Design Advisory Board

ZP-25-517; 355 Ethan Allen Parkway (RL, Ward 7) 355 Ethan Allen Parkway, LLC / Norman Benoit

Proposed addition of two residential dwelling units to each existing building for a change from 12 to 18 residential dwelling units total. (Project Manager, Kirk Dressing)

TO: Design Advisory Board
FROM: Kirk Dressing, Associate Planner
DATE: January 13, 2026
RE: ZP-25-517; 355 Ethan Allen Parkway

Drawing Title
Site Plan

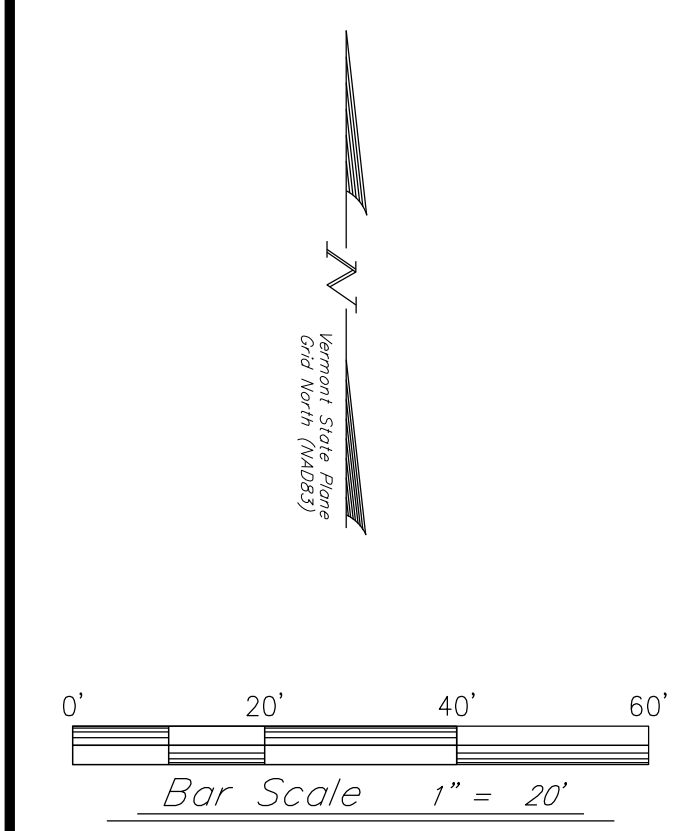
Existing trees are depicted on the submitted site plan, however there is neither an inventory provided, nor information as to whether or not any trees are proposed to be removed, or if additional plantings are proposed. The applicant should provide more information about existing/proposed trees and plantings.

Proposed stormwater infiltration areas are identified on the proposed plan. An Erosion Prevention and Sediment Control plan has not been submitted but one is required.

While the submitted site plan identifies existing trees and proposed stormwater infiltration areas, there is no discrete landscaping plan. One is needed.

The proposed site plan identifies existing dumpster location, however there does not appear to be any enclosure. One is needed.

- EPSC and Stormwater plans are required.
- A landscaping plan is required.
- There is no dumpster enclosure.

BICYCLE LONG TERM PARKING PLAN

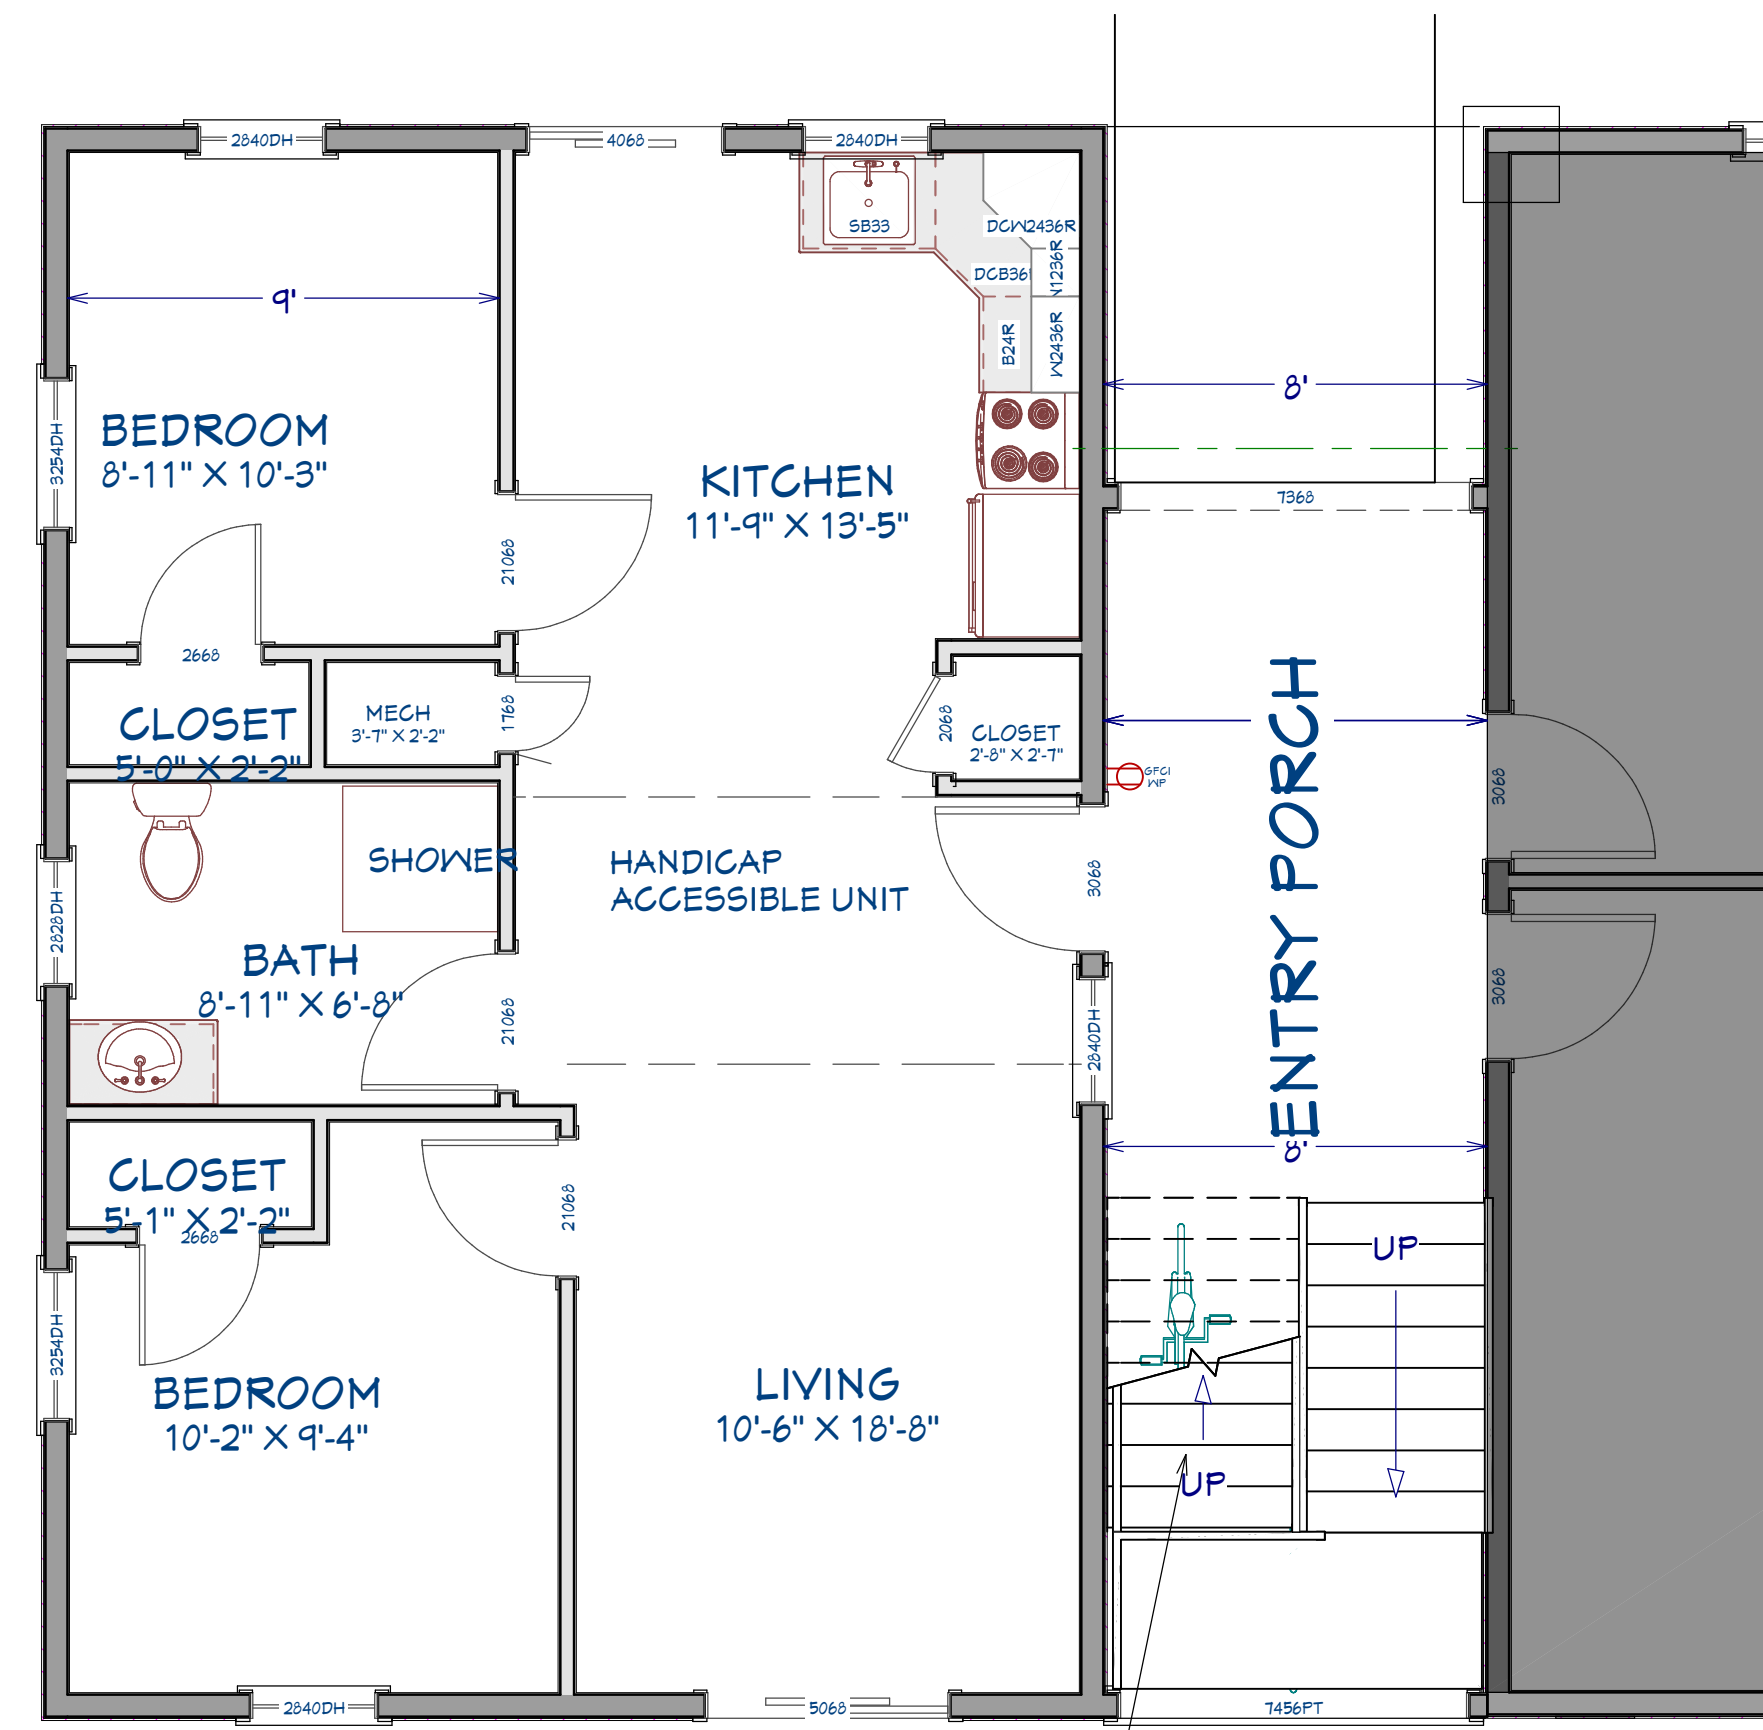
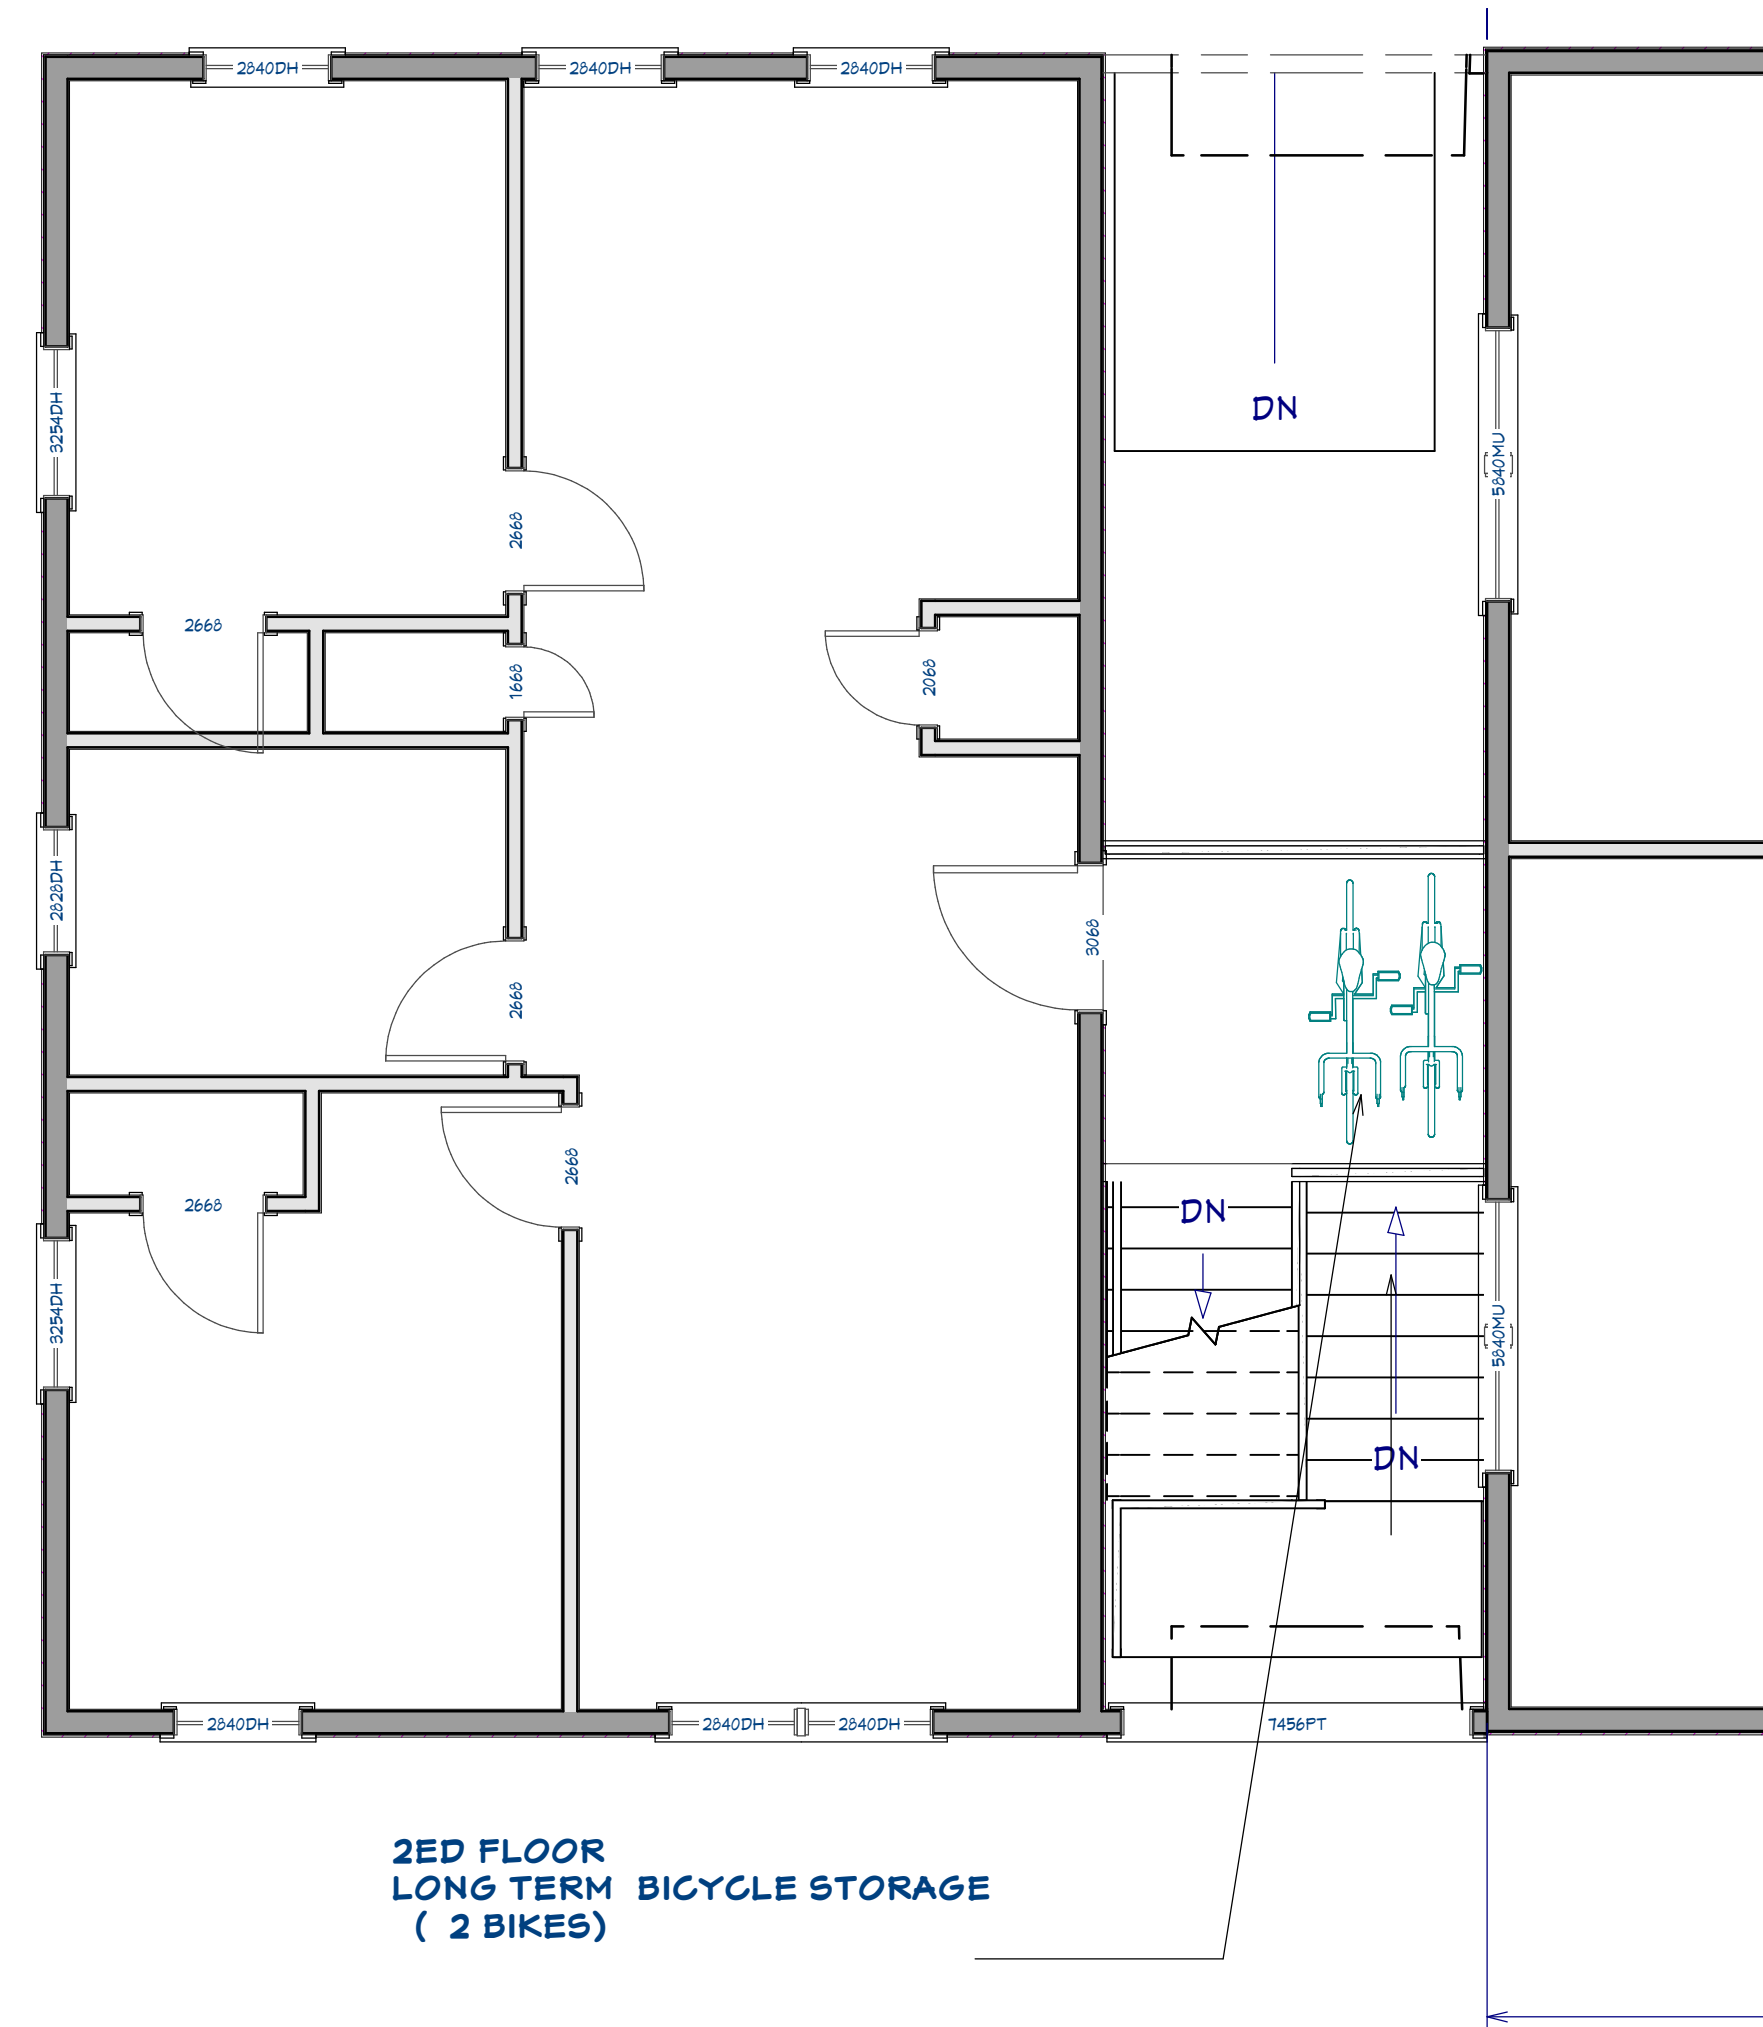
The bicycle parking plan is not clear. There are two different plans for bicycle parking areas, and it is not clear which is being proposed. There are problems with both renderings. Second story bicycle parking is not practical as not everyone is able to regularly carry a bicycle and/or electric bicycle up and down a flight of stairs. The orientation and access to the second level enclosed bicycle parking area is not logical and would likely not function as intended. Maneuvering a bicycle out of the enclosed area would be cumbersome and difficult, and both bicycles would not be able to be removed independent of one another. No changes to vehicular parking or circulation are proposed.

- The bicycle parking plan is not clear, and what has been provided is not practical.
